FACILITY COMPLIANCE INSPECTION REPORT
Division of Waste Management
Solid Waste Section

Date of Site Inspection: February 29, 2012

Weldon Transfer Facility
 2211 Highway 301 North
 Weldon, NC 27839

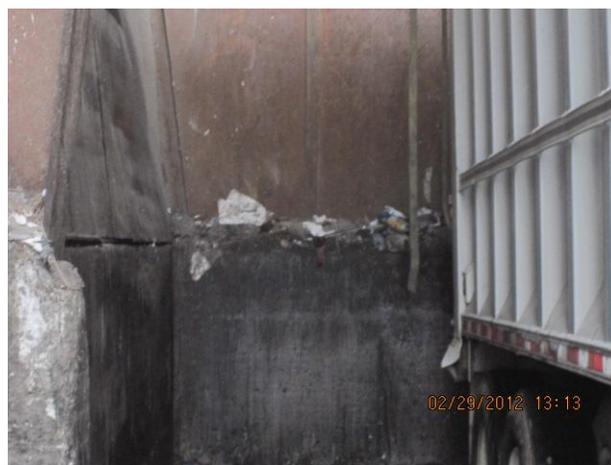
Front lot repaired

Rear lot repaired

Bermed area to keep leachate from going down the approach ramp.

Area needing daily cleaning

Area needing daily cleaning

Repaired approach ramp to tipping floor
